Application of Kyle Williams to rezone properties from R-100 (Residential Medium Lot-100) to RSM (Small Lot Residential Mix) Zoning District to allow for the construction of single family detached residences, at 4994 Rockbridge Road.

PETITION NO: N8. Z-22-1245331 2021-3522

STAFF ANALYSIS

Case No.: Z-22-1245331 **Agenda #:** N8

OVERALL SITE PLAN

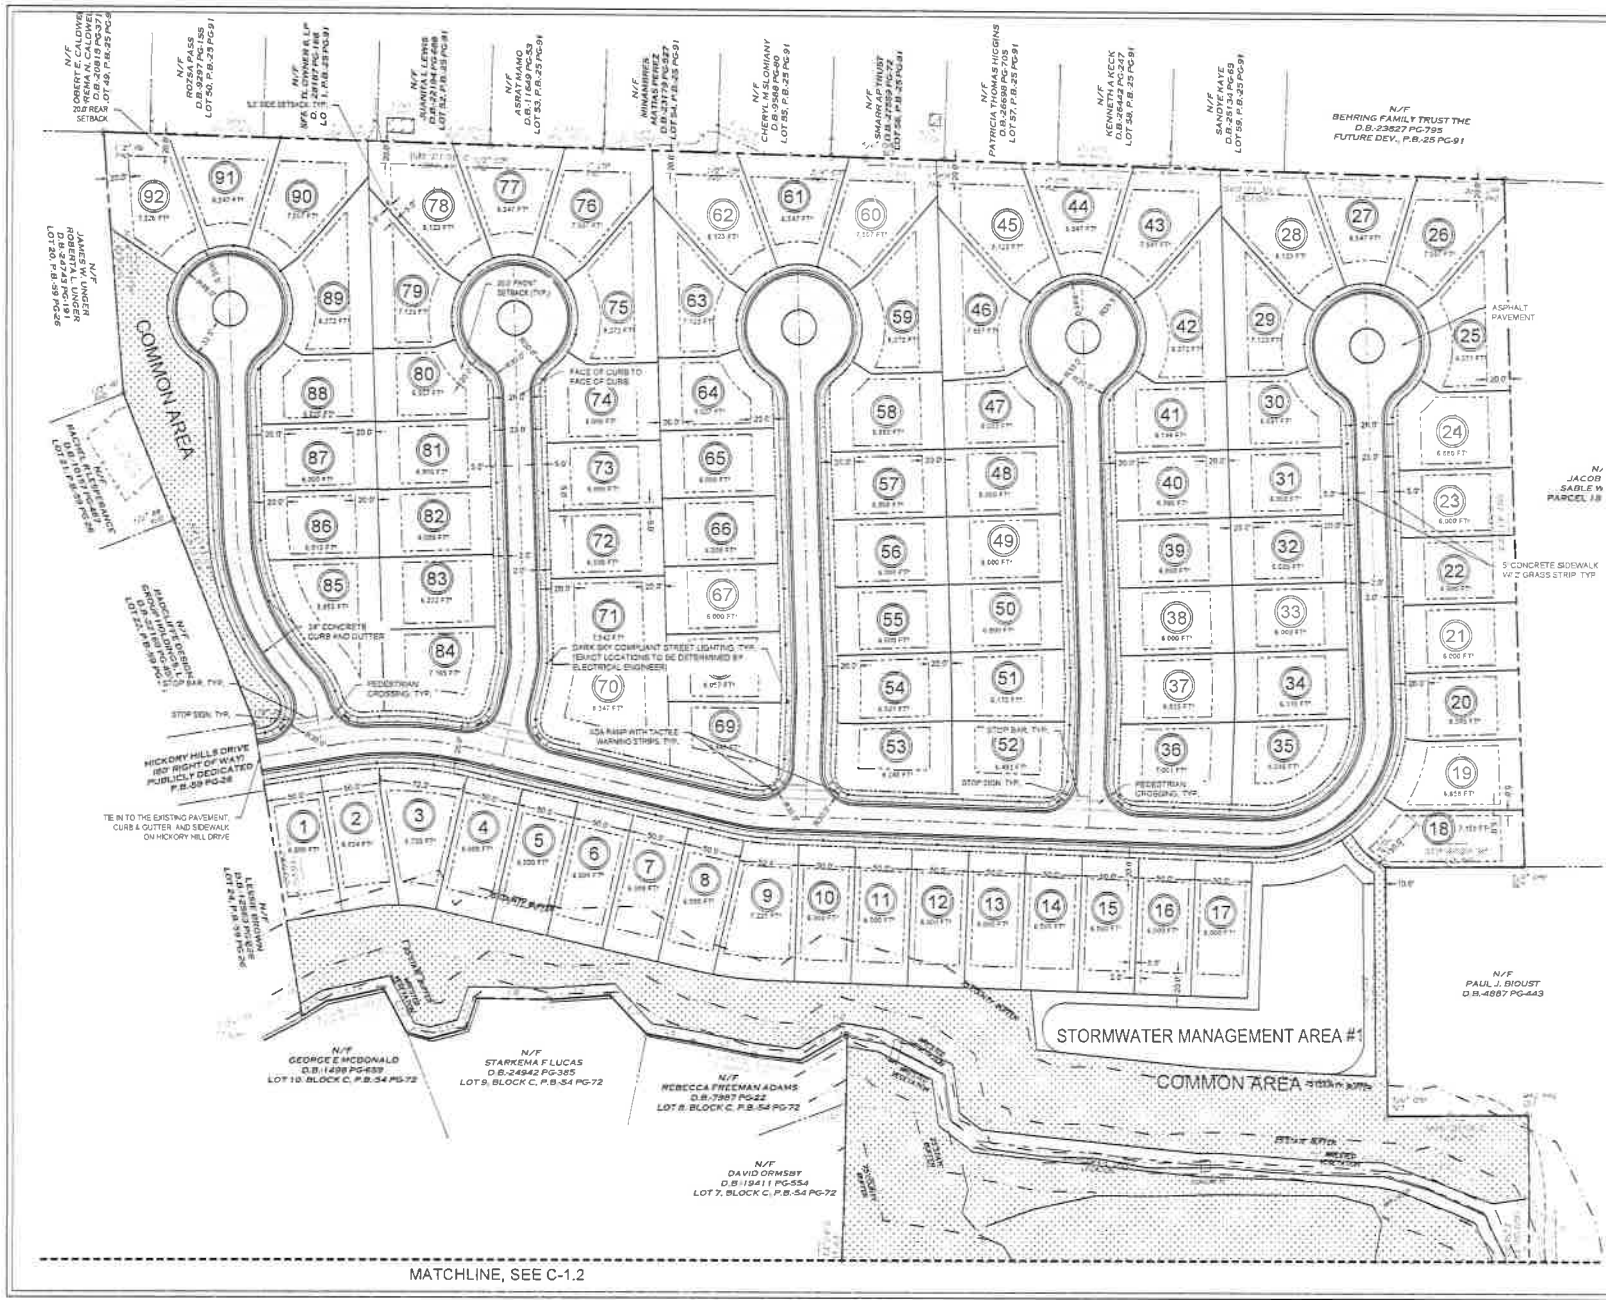
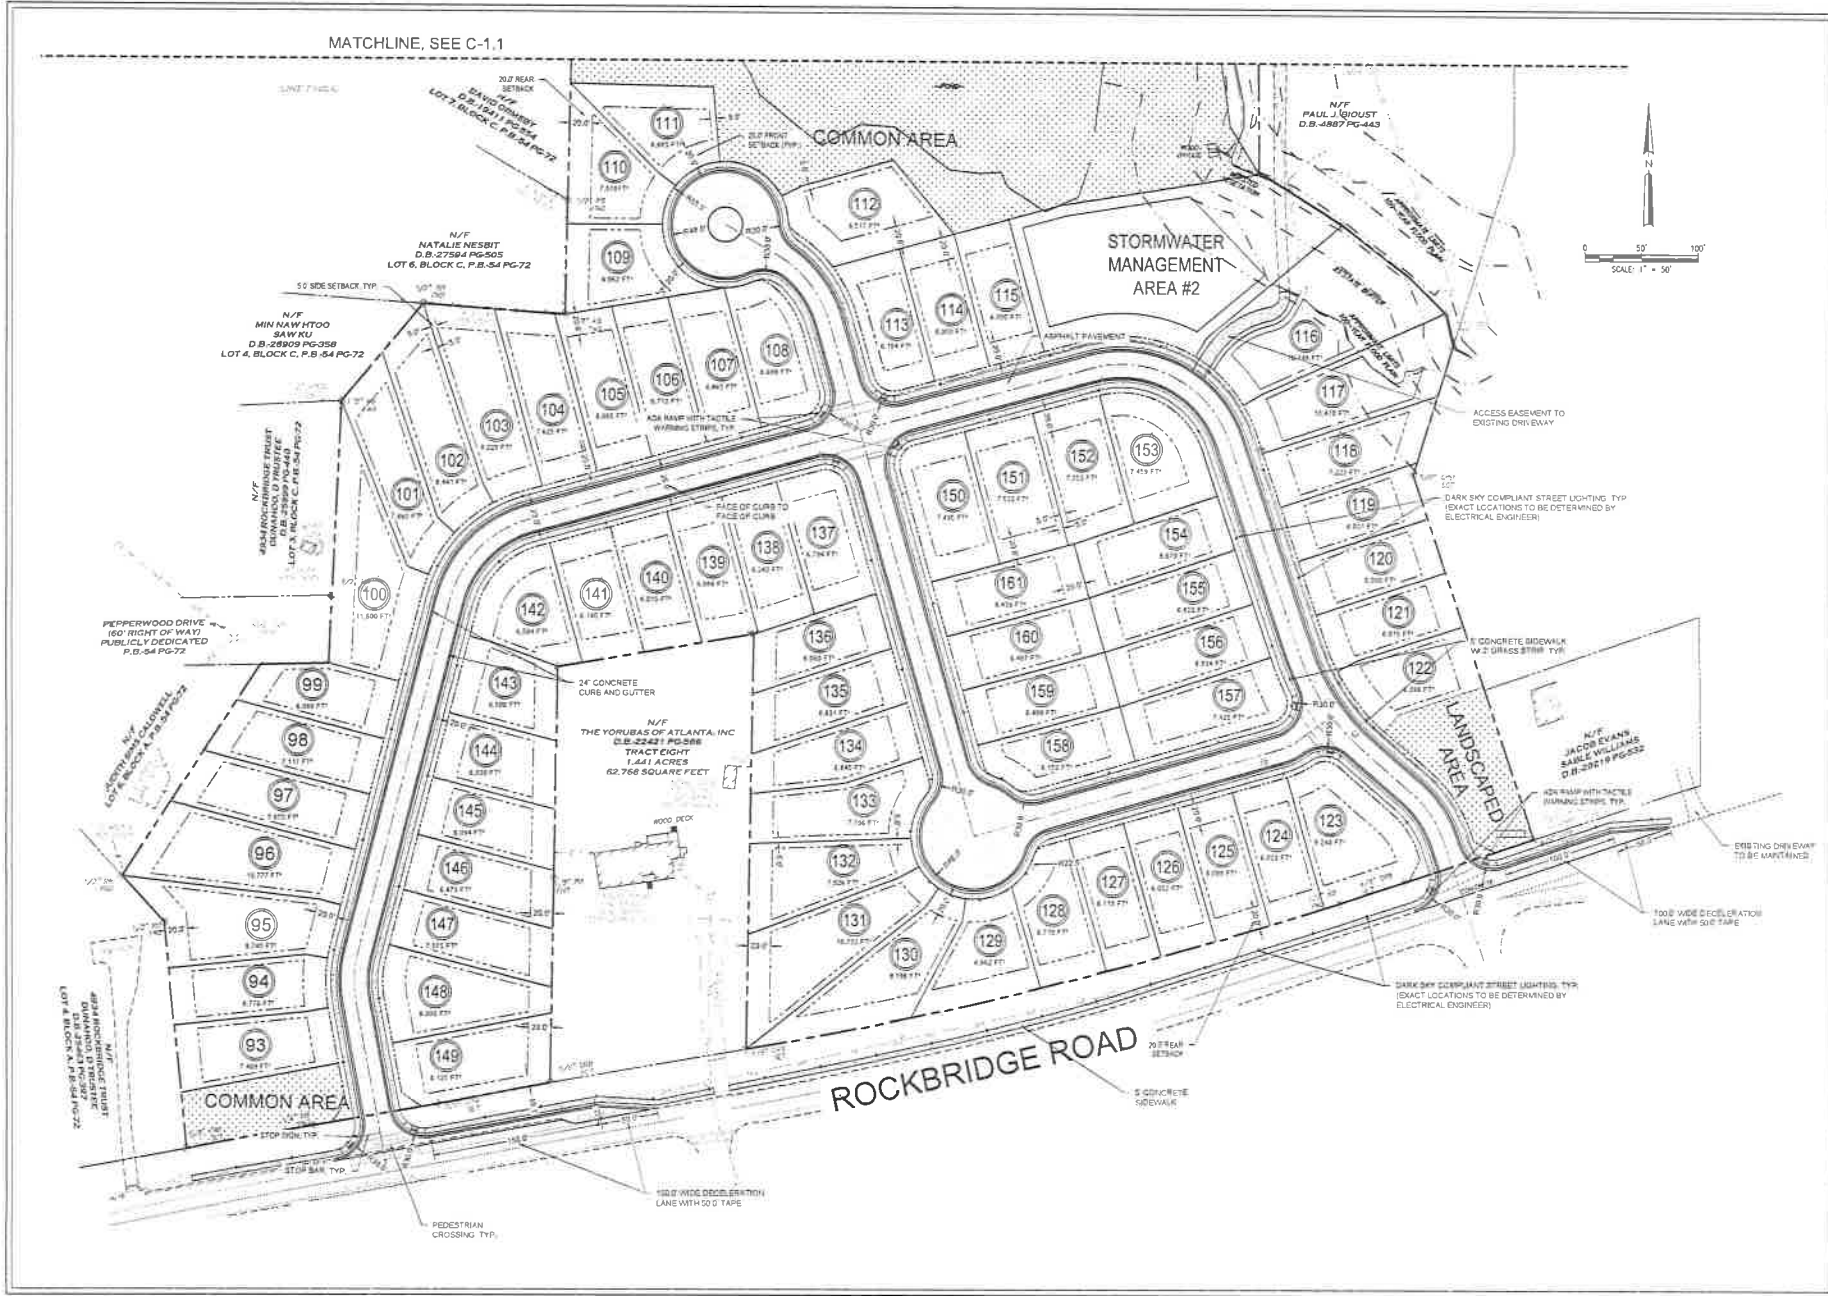
The submitted site plan does not indicate compliance with the perimeter lot compatibility requirements of the *Zoning Ordinance* requiring that proposed lots along the external boundary of the site be at least 80% as large and 80% as wide as abutting single-family lots. Additionally, the *Zoning Code* requires a minimum of 20% open space, and the plan indicates only 12% open space is being provided. The *Zoning Ordinance* requires new streets to be designed to create an interconnected system of grid patterned roads (Section 5.2.3) to allow for adequate and convenient access for pedestrians and emergency vehicles (Section 5.1.1.B.2). The proposed plan's excessive number of cul-de-sacs along the north side of the property is not consistent with this objective. Since the proposed plan does not show compliance with abutting single-family lot sizes, required open space, and road layout, the request does not appear to be compatible with adjacent and surrounding properties.

The submitted site plan does not indicate compliance with the perimeter lot compatibility requirements of the zoning ordinance requiring that proposed lots along the external boundary of the site be at least 80% as large and 80% as wide as abutting single-family lots. Additionally, the zoning code requires a minimum of 20% open space, and the plan indicates only 12% open space is being provided. The *Zoning Ordinance* requires new streets to be designed to create an interconnected system of grid patterned roads (Section 5.2.3) to allow for adequate and convenient access for pedestrians and emergency vehicles (Section 5.1.1.B.2). The proposed plan's excessive number of cul-de-sacs along the north side of the property is not consistent with this objective. Since the Plan does not show compliance with abutting single-family lot sizes, required open space, and road layout, the request
